Carisbrook Levee Review Report

Review of Floodplain Management since 2013

Report Number: P-FY20242892-PWO-DAM-RP-001

August 2024

Figure 3-2 Example of Internal Flood Map when stormwater pipes under a levee bank are closed trapping any rainfall occurring within a levee system

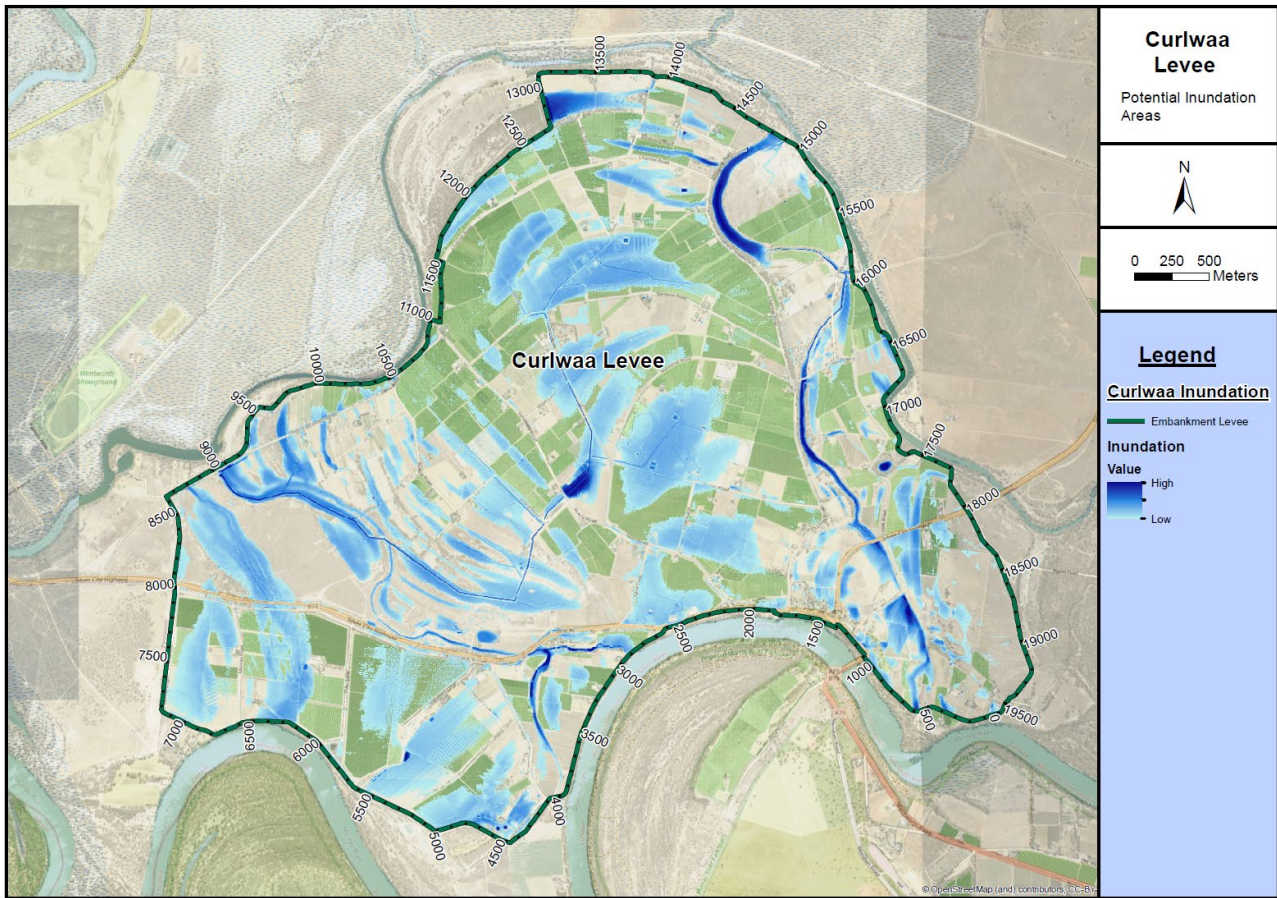
From the author’s more than 35 years’ experience, there have been too many instances of landholders complaining about “different” flooding behaviour BEHIND a levee bank AFTER a levee bank has been constructed to ignore. Even though, in some instances, there appears to be no “engineering reason” why there should be any problem. It must be remembered that all levee banks are a “Flood Modification” measure, and this applies not only to water in front of the levee but behind it as well.

This will also require the flood model to be updated showing all changes that have occurred since 2013 (e.g., new developments, any new drains etc.).

It is recommended that an “Internal Flood” study be undertaken.

Figure 4-1 Incorrect Factor of Safety

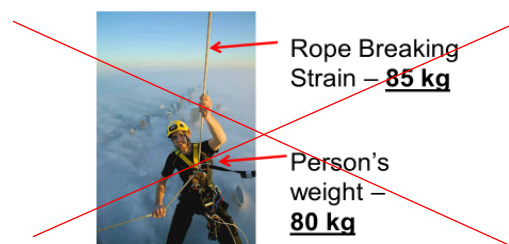
In all engineering designs there is a factor of safety used to allow for variability that is inherent in all things. For example, loads used to design bridges and buildings have a factor of safety of 1.2 – 1.5 (amongst other factors of safety used in their design). A climbing rope or crane cable will often have a factor of safety of 3 – 4, not 1.05.

Figure 4-7 Some locations of reduced design freeboard

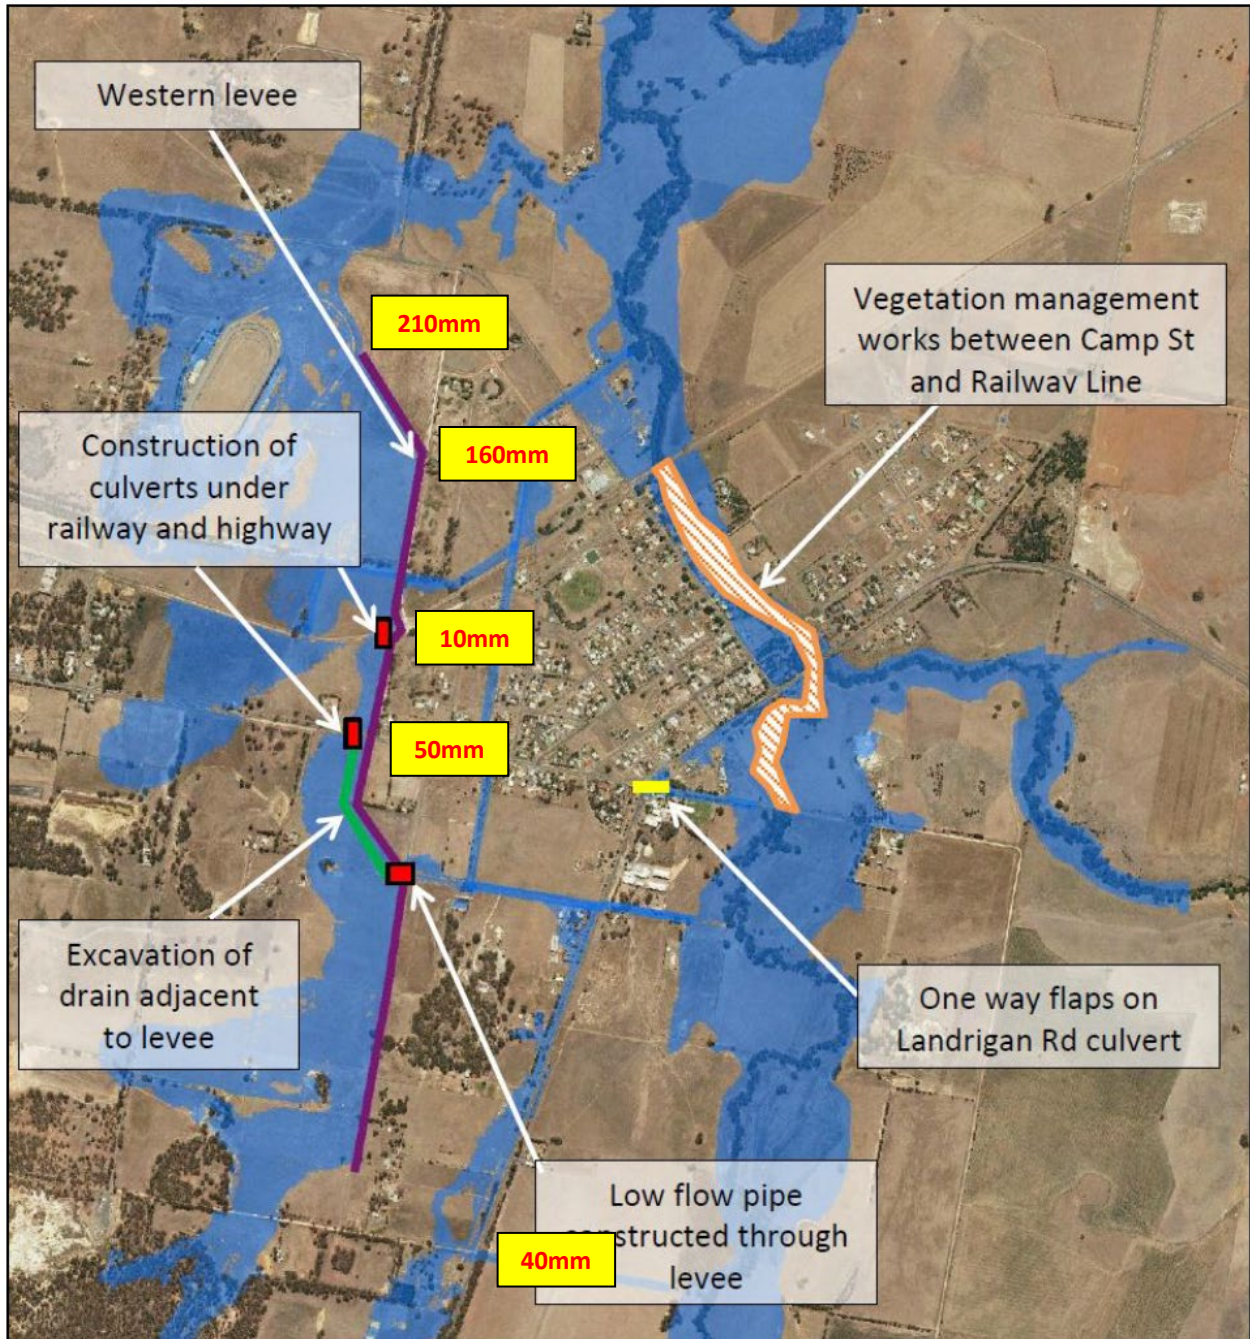
The Table has been checked against the As-Constructed drawings which show that at critical locations, there is even less than the freeboard shown below (e.g., at Pyrenees Highway the As-Constructed levels are from 195.668 – 195.515 with the Design Flood Levels being 195.70 – 195.51).

1. Three (3) locations where the levee is significantly below Design Level
2. One section where Design and As-Built Crest levels are below Design Flood Level.

Raise the crest level of all locations where the freeboard is less than 300mm or have a plan in place to construct temporary levees during the emergency (if there is time).

Figure 4-8 Williams Road design longsection

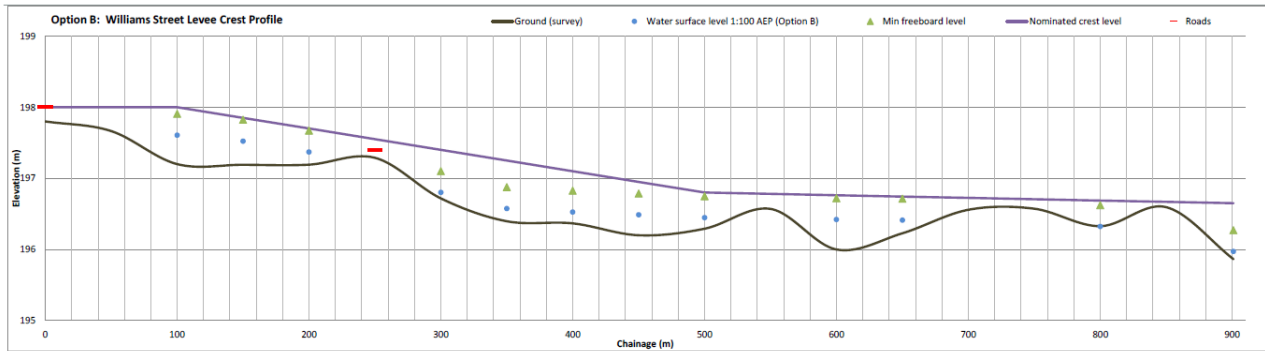
It is noted that in the Entura Preliminary Design Report (2015), there is a long section of the (then) proposed Williams Road Levee Bank as below. However, it is noted that levels are only taken at every 50m, not every metre. It is easy to miss critical locations when only looking at 50m intervals in (very) flat floodplains.

Figure 4-9 Design Levee Crest Level, As-Built Crest Level & Design Water Level – Williams Road

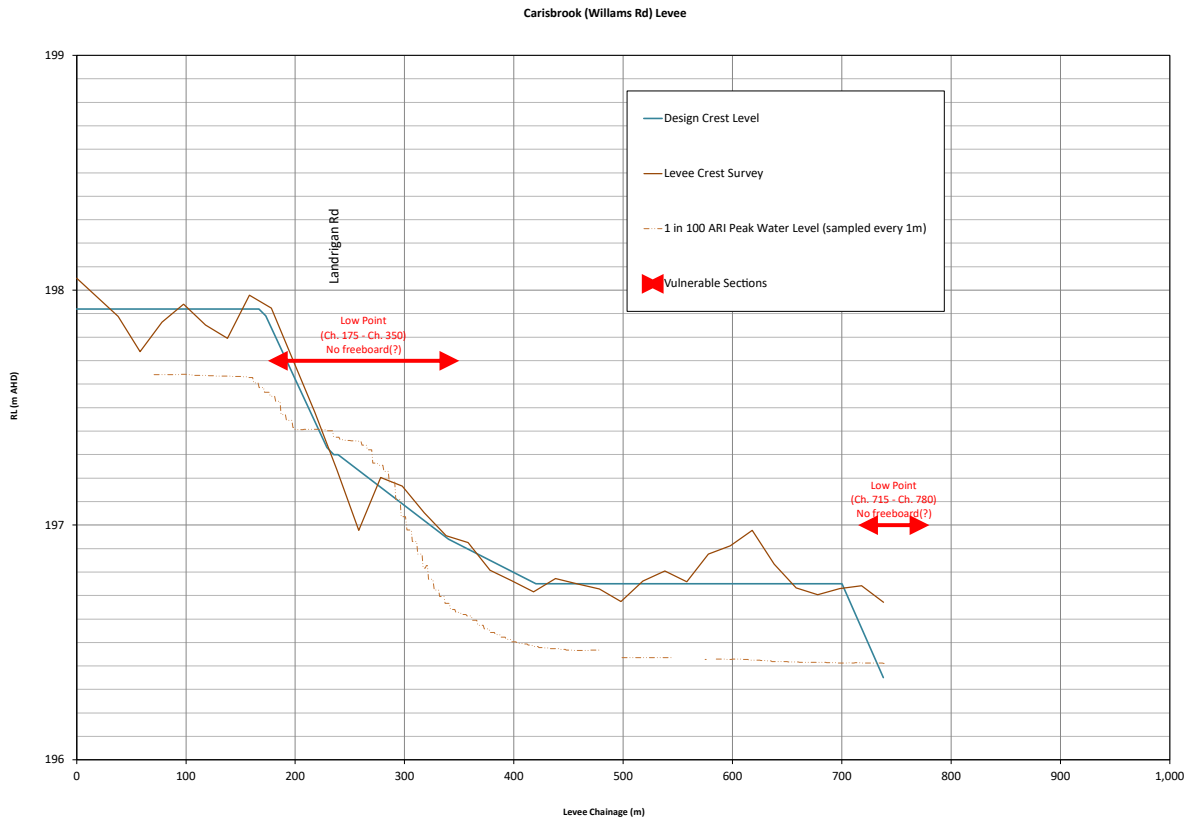
Given the latest (detailed) assessment of the Design, As-Built and Flood Levels as well as concerns expressed by members of the Community and Cemetery Trust, this conclusion is not agreed to. It is VERY flat country and small changes can make big differences in water levels that do not always show up in a Flood Model. Afterall, no model is perfect.

Figure 4-12 Location of “Low Point” in flood model

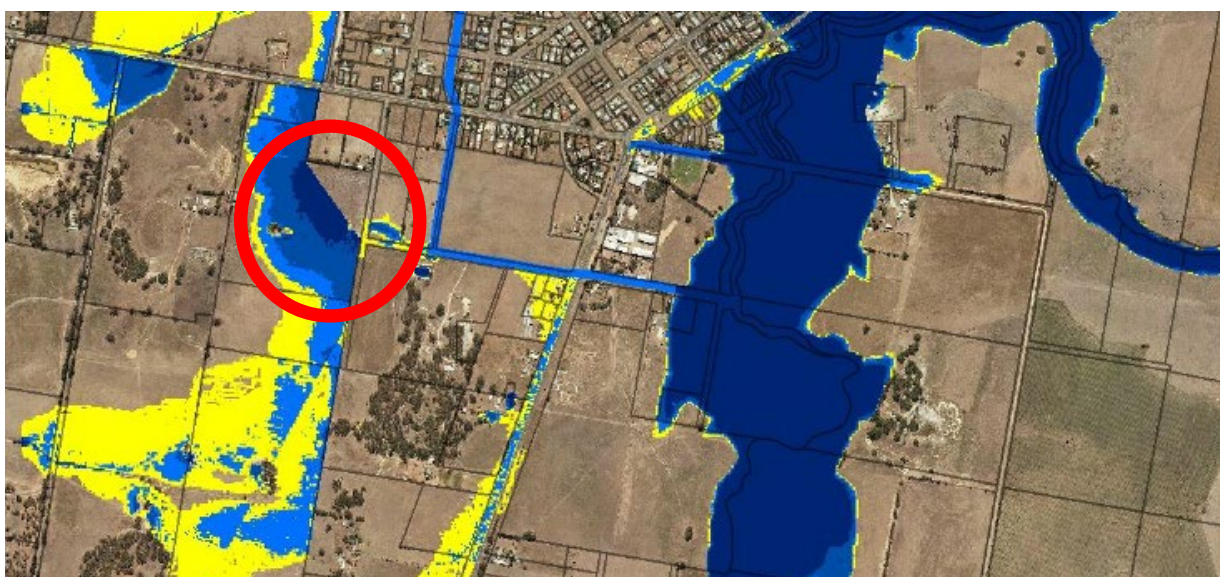
This location was identified as a low point in the general topography in the 2013 Flood Study where water would sit behind the levee and not be able to drain away (as shown below).

However, the 2016 Entura report designed a “Low Flow” channel parallel to the Western Levee for its’ entire length. This clearly shows that for the entire length of that channel, it falls towards the north ending up in the Racecourse area. That is, this “Low Flow” Channel will drain all remaining flood waters from behind the levee at this “low point” anyway, thus removing the need for any drainage pipe through the levee at this location.

Figure 4-16 House on northern side of Pyrenees Highway culverts

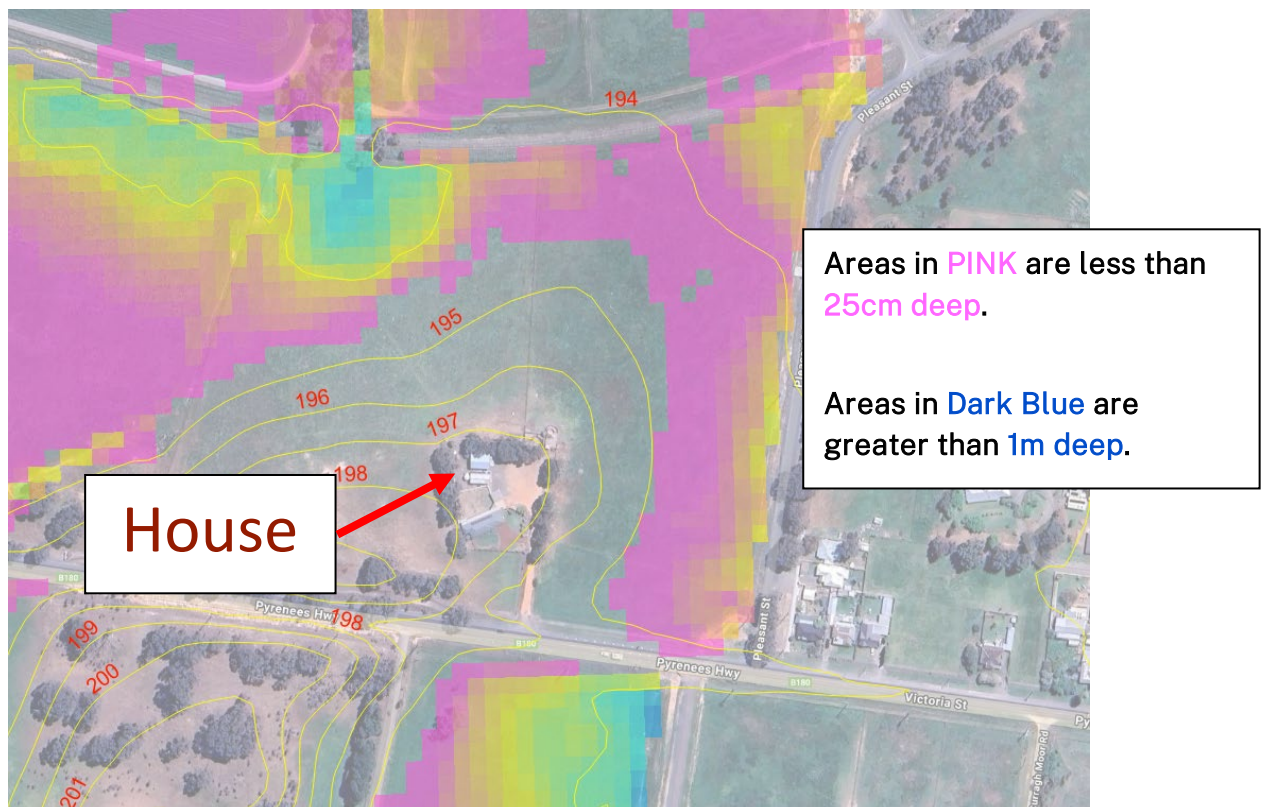
It should be noted, there is a house on the northern side of the culverts, however it is some 2m higher than the design flood levels and (very) unlikely to be impacted.

However, increasing the number of culverts may also have reduced the crest level of the levee bank, thus making the cost of the levee construction cheaper thus offsetting (to some extent) the increased cost of any extra culverts.

Figure 4-17 Inflow hydrographs – 2019 Flood Study

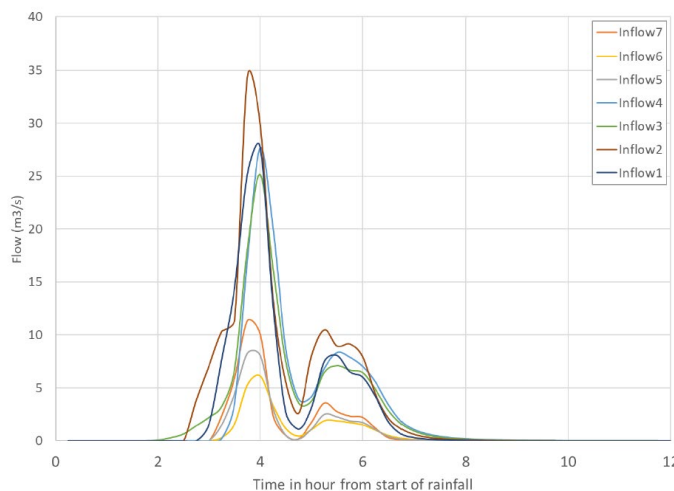
The 2019 Flood Study included the Inflow Hydrographs used for both the 2013 Flood Study modelling and the revised 2019 Flood Study modelling. This allows, for the first time, a way to independently approximate if the “Retarding Basin” culverts at the Pyrenees Highway could work. That is, another way apart from trusting the computer. This was done by running the graph through a computer program to generate points on each of the Inflow Curves (being Inflow Points 4, 5 & 6).

It is recommended that more detailed calculations be undertaken by the Flood Modelers and the outcomes presented in Table form as well as a graphic(s) showing the extent of the Flood Storage area upstream of the Culverts to verify this is the case.

Figure 4-19 Western Levee “Retarding Basin” – from Flood Model Animation Video

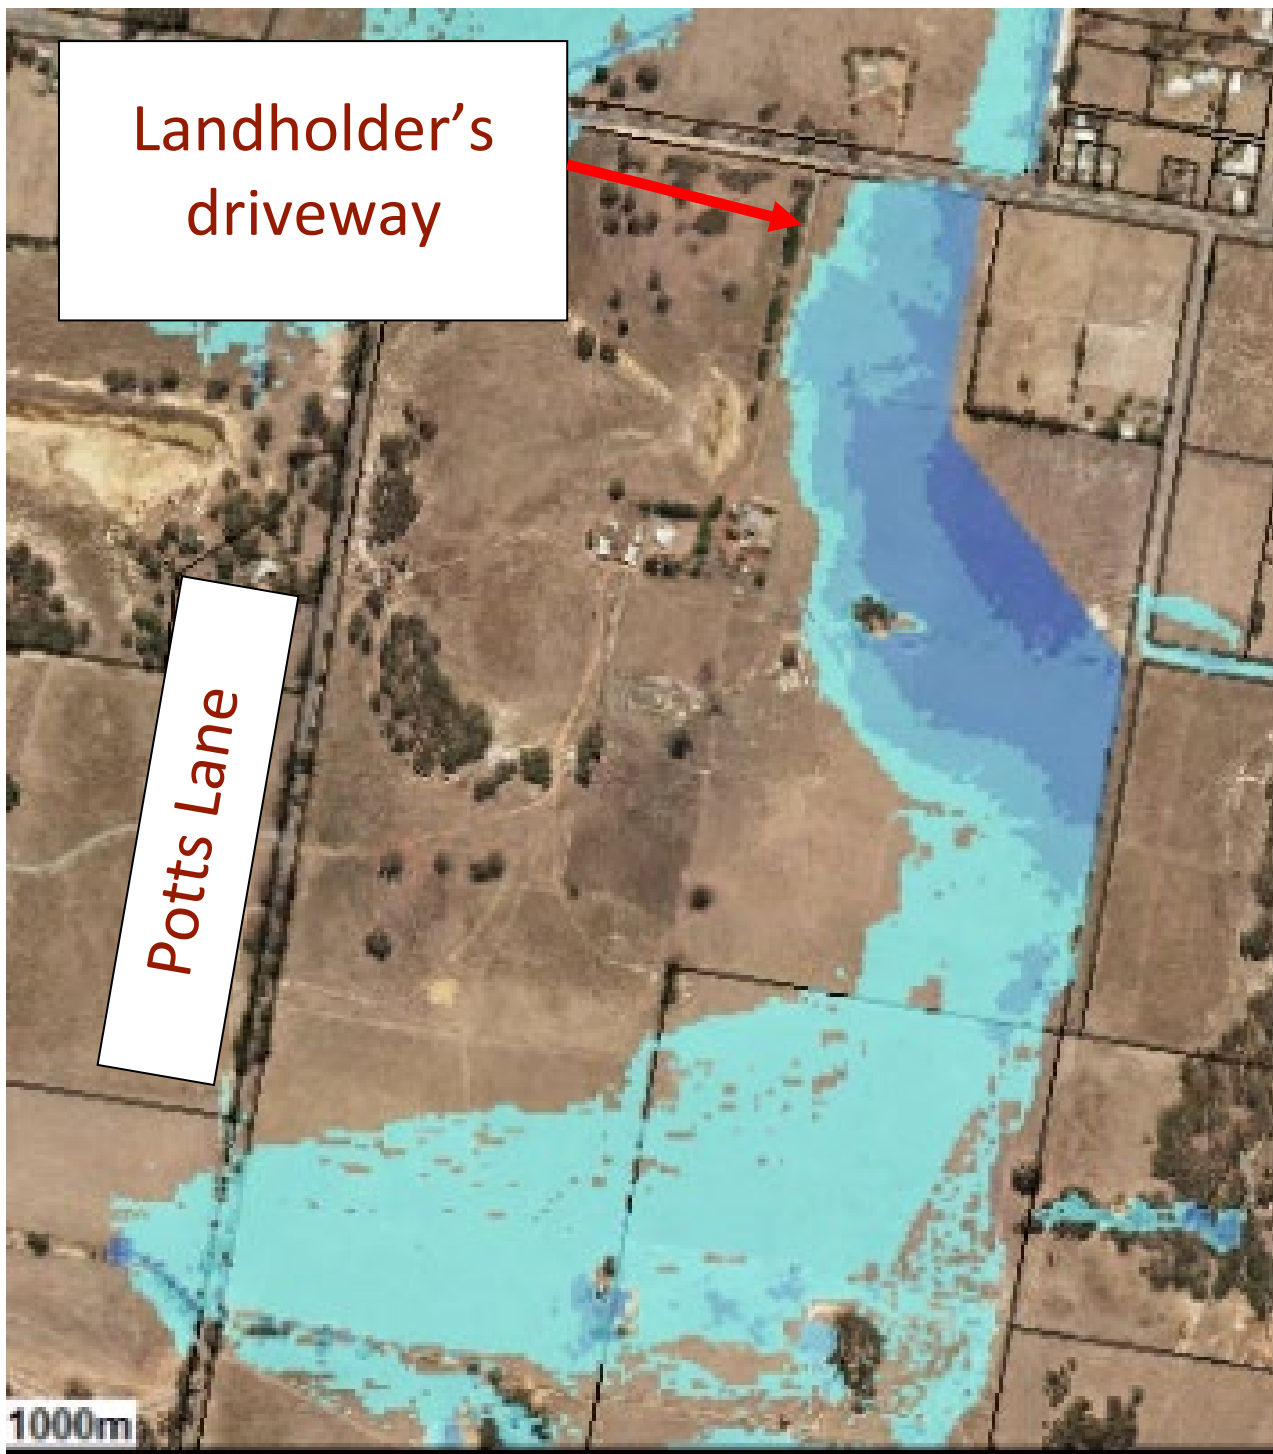
It should also be noted that the entire area south of the Pyrenees Highway MUST be used to store that water. As such, any interference with that storage (say construction of a contour bank) can seriously change the hydraulics of the flood flows thus jeopardising the safety of the western levee.

For the Critical Design Storm MIKE FLOOD Model run, run an additional scenario with up to (say) ten culverts under the Pyrenees Highway (noting that there is a house to the northwest of the culvert outlet). Include any additional culverts needed underneath the railway line also.
